RANCHO SANTIAGO COMMUNITY COLLEGE DISTRICT

ADDENDUM NO. 1

Bid #1413 BR Signage and Wayfinding
at
Santiago Canyon College

January 18, 2022

- A. PVC Pipe and fittings to match existing.
- B. Use 45 degree elbows for off sets in lieu of 90 degree elbows.
- C. Adjust sprinkler heads to spray away from monuments.
- D. Sprinkler head adjustment & relocation to be approved by District representative.

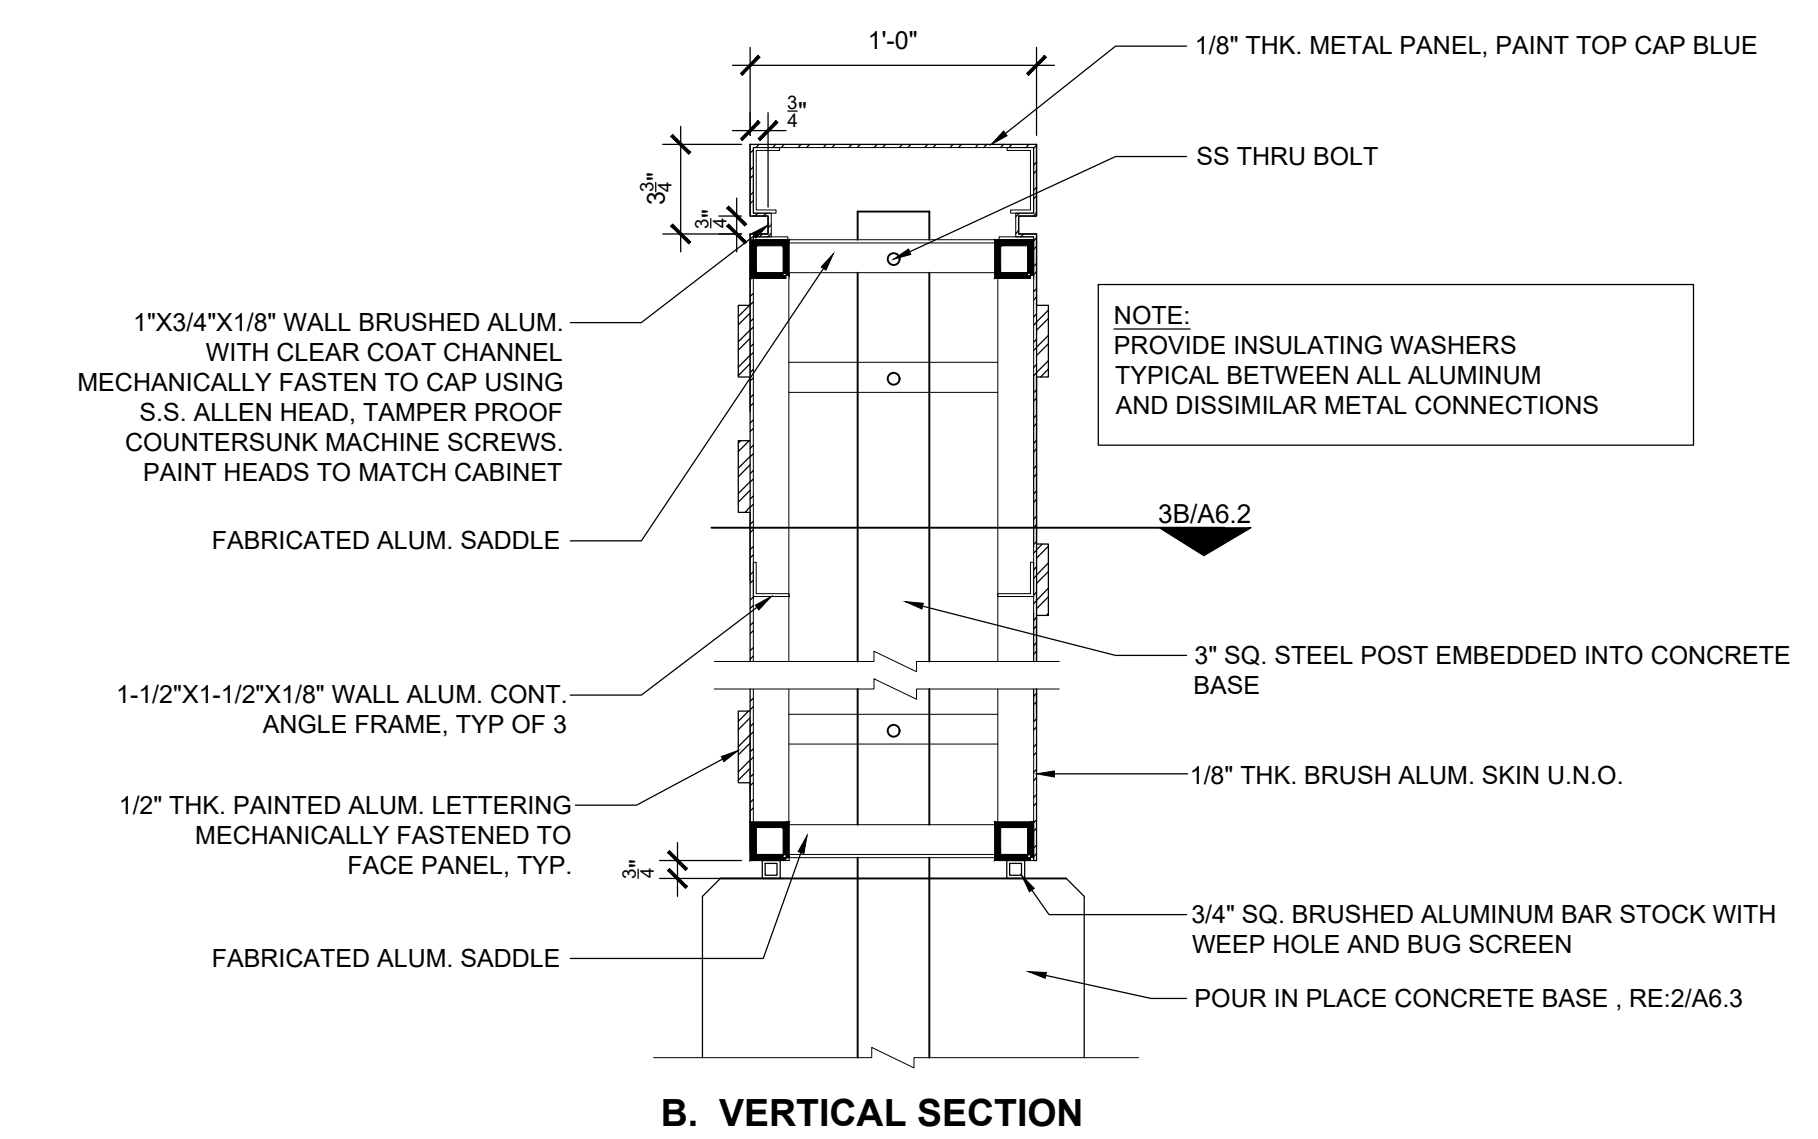
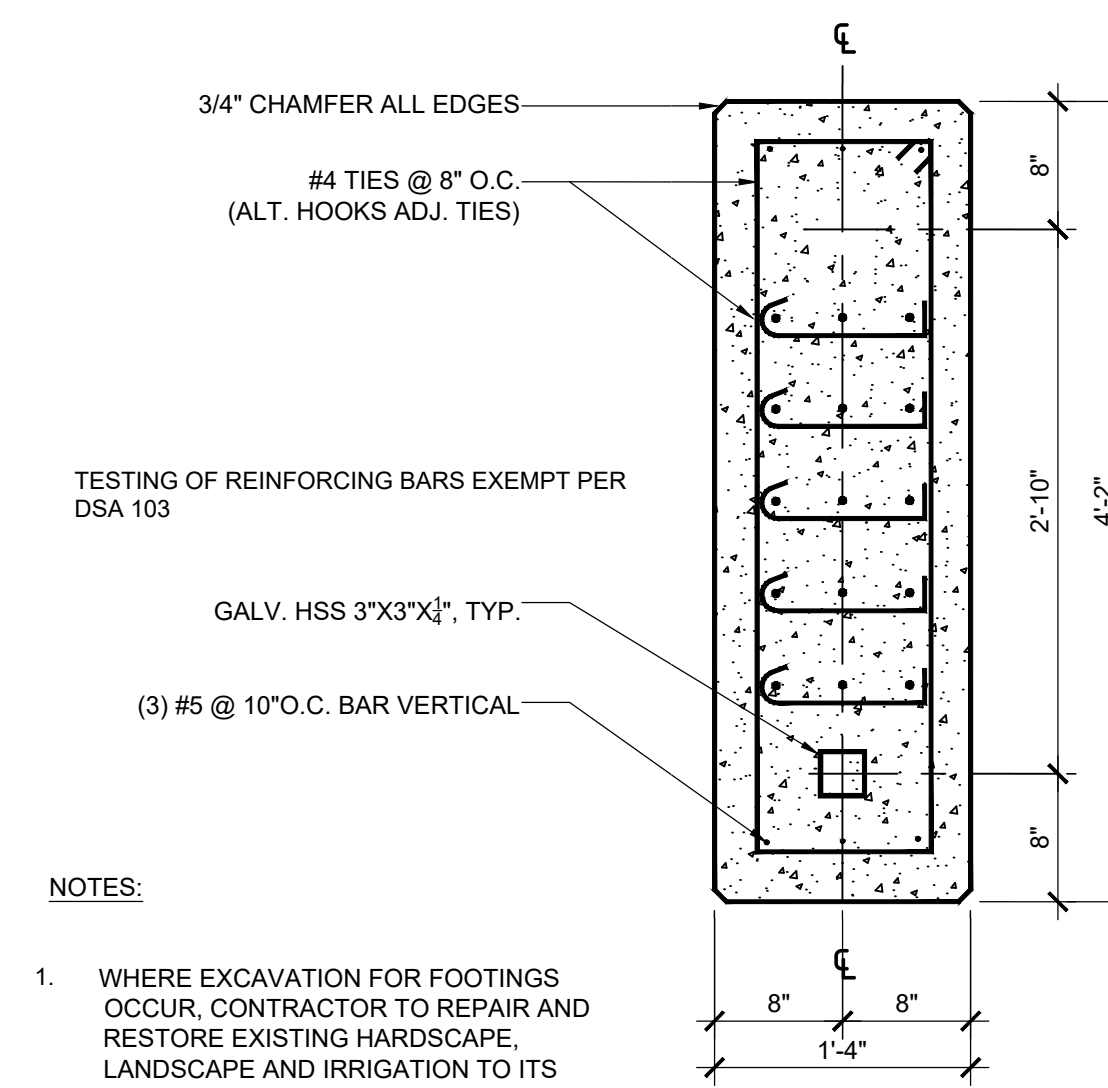
Refer to attached Drawing A6.3, Sign Details, General Notes. Revise General Note No. 1 as follows:

1. Contractor to repair existing hardscape, landscaping and irrigation at new construction, field verify.
 - A. PVC pipe and fittings to match existing.
 - B. Reroute with 45-degree elbows in lieu of 90-degree elbows.
 - C. Adjust adjacent existing sprinkler head positioning where spray is not spraying monuments.
 - D. Sprinkler heads to match existing and approved by District representative.
